CITY OF BLOOMINGTON PLAT COMMITTEE

December 10, 2018 @ 4:00 p.m. CITY HALL - KELLY CONFERENCE ROOM #245

CASE #: DP-10-18 DATE: December 10, 2018

REQUEST: The petitioners are requesting final plat approval for a two lot subdivision zoned RS (Residential Single Family).

TRADES DISTRICT AMENDMENT 1 FINAL PLAT **BLOOMINGTON TOWNSHIP** MONROE COUNTY, INDIANA

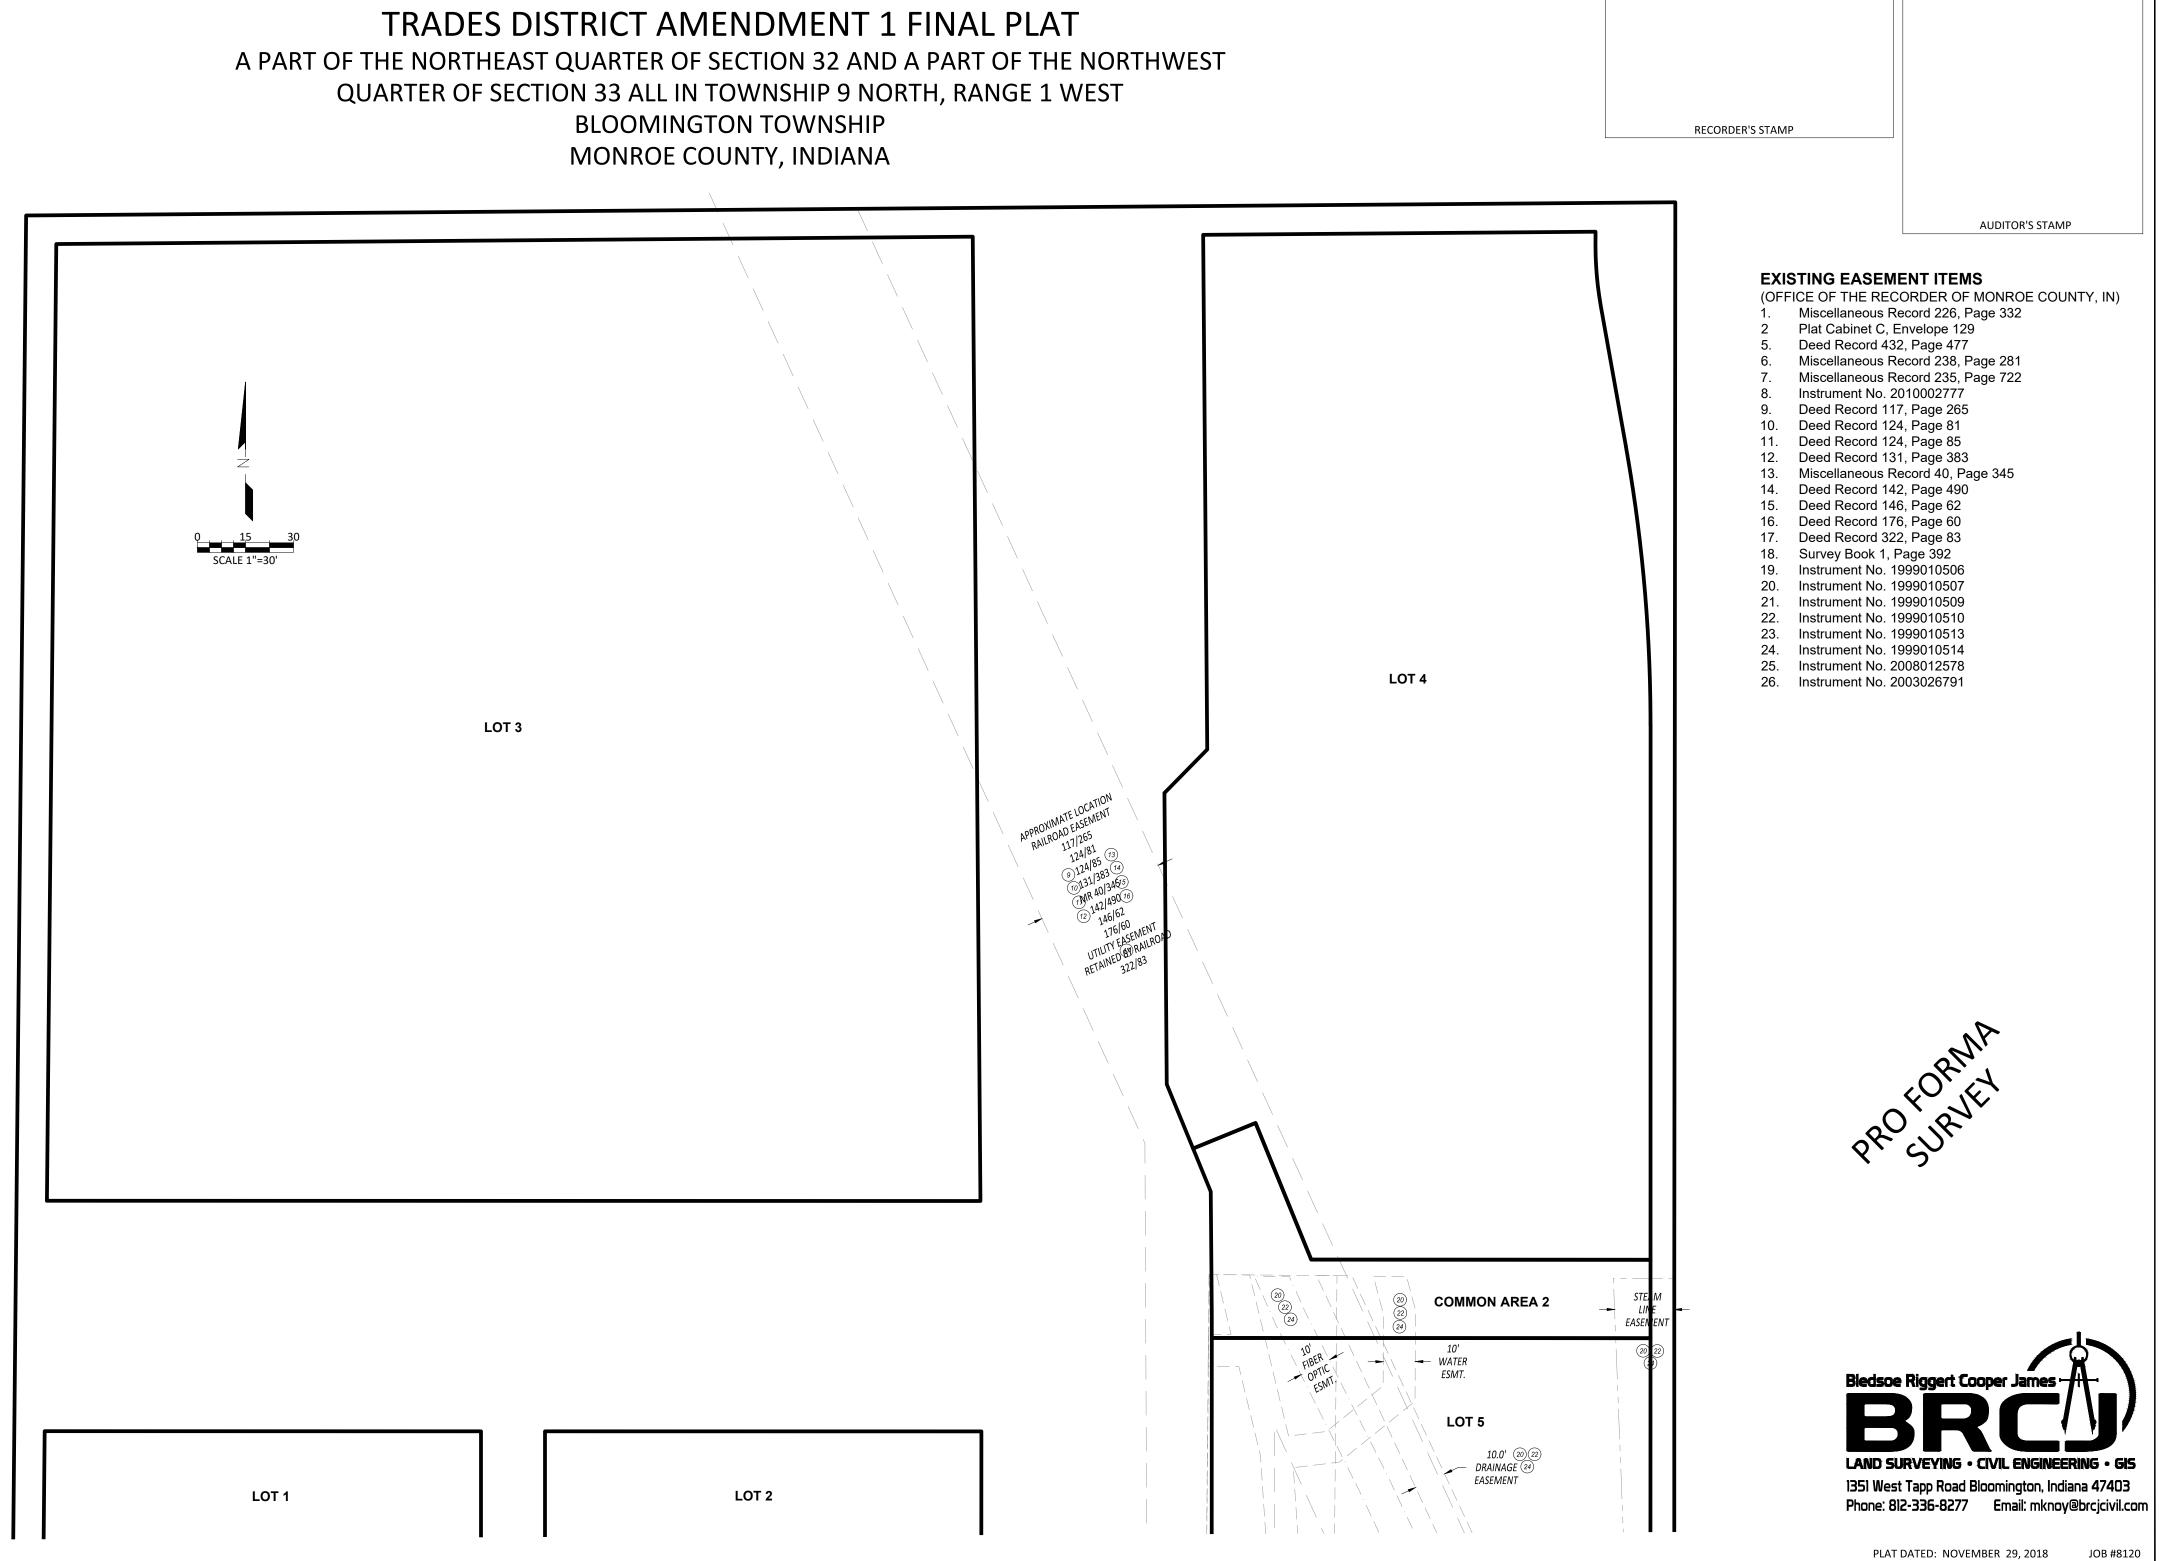
Right of Way: A variable width but roughly 72 foot right-of-way for the new portion of Madison Street is proposed. The right of way will contain room for two travel lanes, on-street parking, sidewalks, planting areas, and green infrastructure water treatment features.

additions in the right-of-way, including tree plat and sidewalk. 9.5 feet of right-of-way was dedicated along Rogers Street in that plat, which amounts to roughly 9 feet lower than the required Thoroughfare Plan width of 40 feet. Department recommends carrying forward that amount with this amendment.

The proposed petition meets UDO requirements with the exception of the right-of-way issue discussed above. All future development on the newly created lots will be required to meet UDO requirements, unless otherwise granted deviation by the Plan Commission or variance by the Board of Zoning Appeals. No concerns were raised by members of the public during the Preliminary Plat process.

1. Plat Signature block will be amended to reflect approval by Plat Committee, as well as correct minor scrivener error.

3. Following all revisions to the Final Plat, the President of the Plan Commission or Chair of the Plat Committee shall sign and seal the plat at the appropriate locations.
